ACCESS REPORT PROJECT APPLICATION

JUSTINIAN HOUSE REDEVELOPMENT

19TH OCTOBER 2007

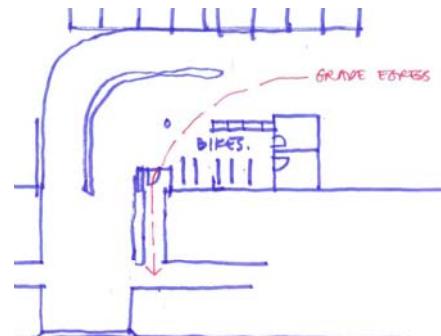
36. The plans indicate that there will be accessible toilets and showers on levels 1, 2, 3 and subject to the following minimum sizing, internal spatial areas and doorway circulation spaces then the accessible sanitary facilities can comply with AS1428.1 and Part F2.4 of the BCA.

- WC 12.6 (Level 1) – 1800mm X 2600mm with a 1800mm X 3000mm doorway approach.
- WC 1.7 (Level 2) – 2000mm X 2200mm with a 2000mm X 2000mm doorway approach.
- WC 2.8 (Level 2) – 2000mm X 2400mm with a 2000mm X 2000mm doorway approach.
- WC 3.9 (Level 3) – 2000mm X 2400mm with a 1600mm X 2000mm doorway approach.

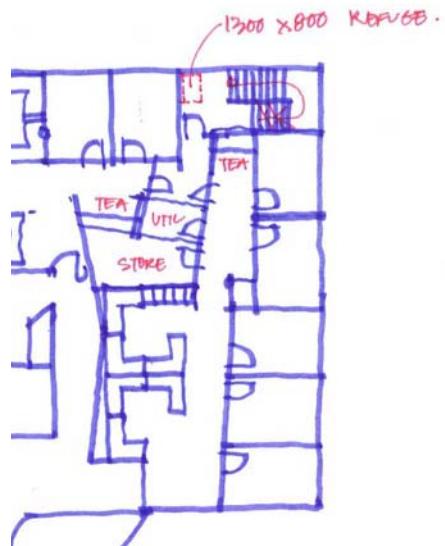
41. **Level 3** – The adjoining sketch illustrates a fire isolated stairway at level 3 that can facilitate an appropriate opportunity for the provision of a 1300mm X 800mm wheelchair refuge area to satisfy this aspect of Council's DCP 2002.
